**ATASCOCITA RECYCLING AND DISPOSAL FACILITY
HARRIS COUNTY, TEXAS
TCEQ PERMIT APPLICATION NO. MSW 1307D**

PERMIT AMENDMENT APPLICATION

Re: Atascocita Recycling and Disposal Facility - Harris County
Municipal Solid Waste (MSW) - Permit No. 1307D
Permit Amendment Application - First Notice of Deficiency (NOD)
Tracking Nos. 14452326 & 14476346; CN600127856/RN100216142

This response to the First Notice of Deficiency, addressed to Mr. Steve Jacobs, Director of Landfill Operations, dated December 14, 2010, is submitted on behalf of Waste Management of Texas, Inc. The permit amendment application has been revised as appropriate and one original and three copies are enclosed with this letter. The revision number and date are noted on each revised page and the revisions are highlighted as requested. Our responses to the Texas Commission on Environmental Quality (TCEQ) staff comments are presented below in the order received.

IA.10A

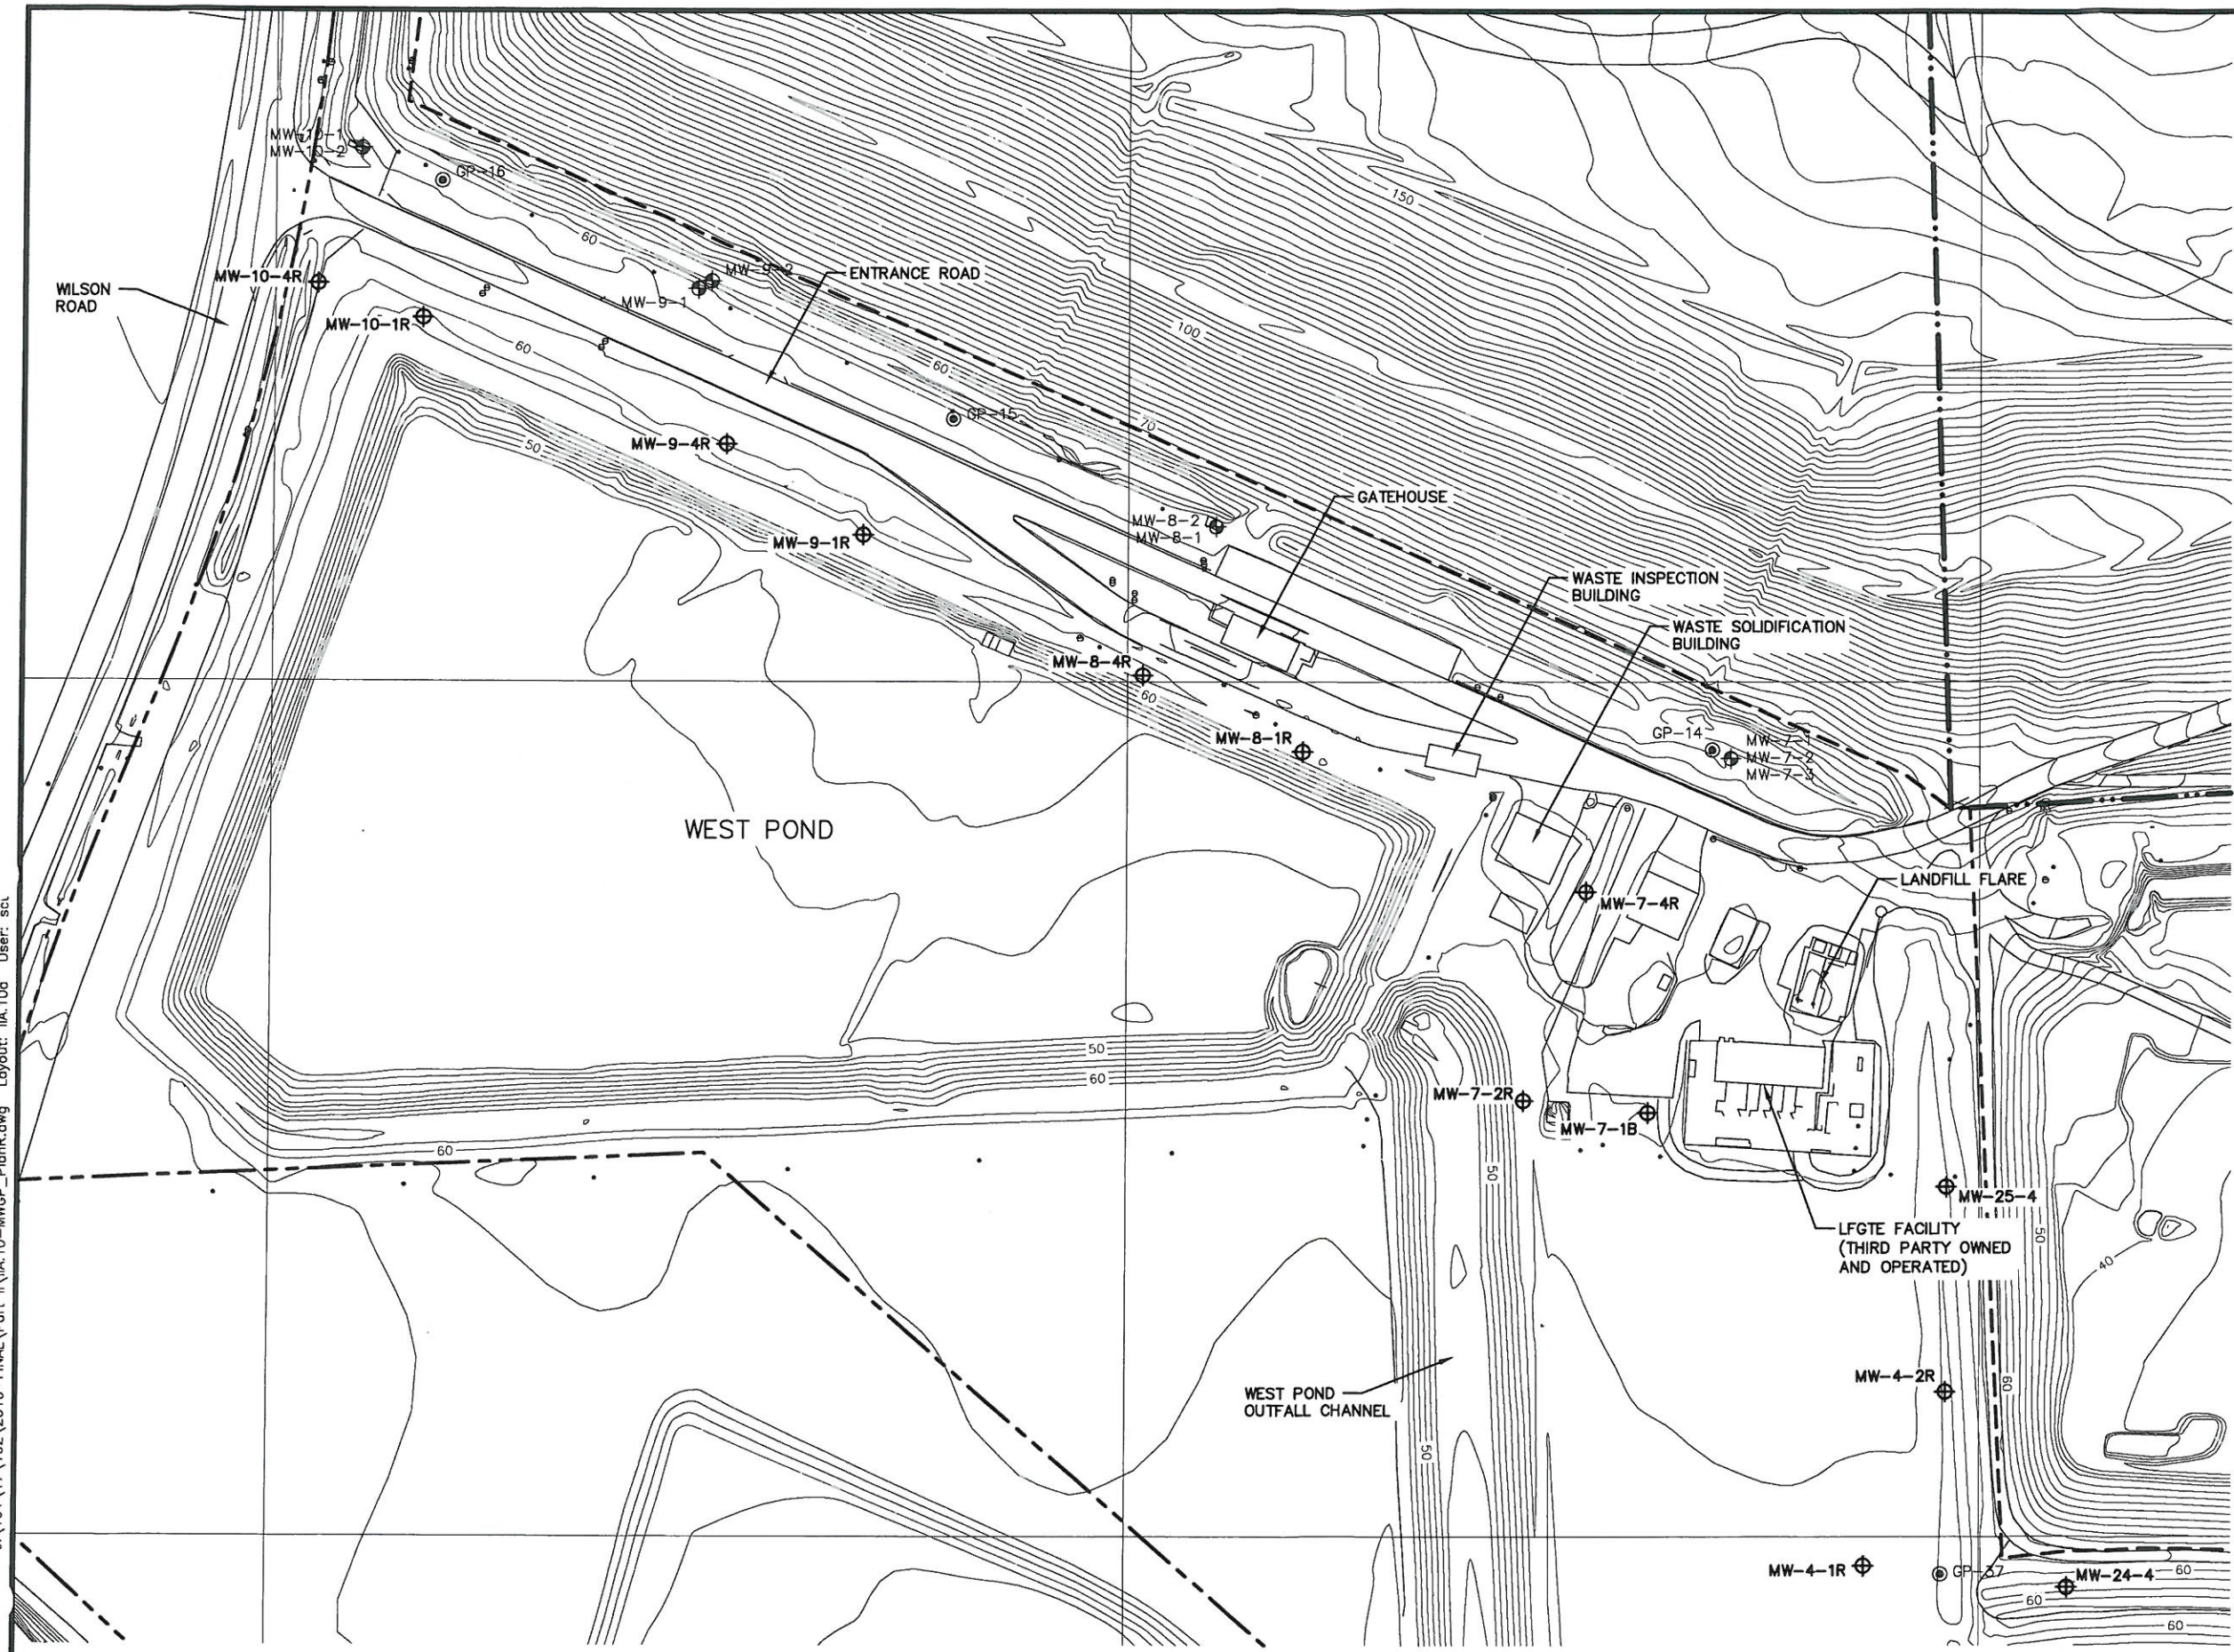
44. Some of the well symbols and labels on Drawing IIA.10 (Groundwater and Landfill Gas Monitoring Plan) are not readable. Please revise the drawing so that all information is legible.

RESPONSE: *As requested, Part II, Drawing IIA.10 has been revised to clarify locations of groundwater monitoring wells and landfill gas probes.*
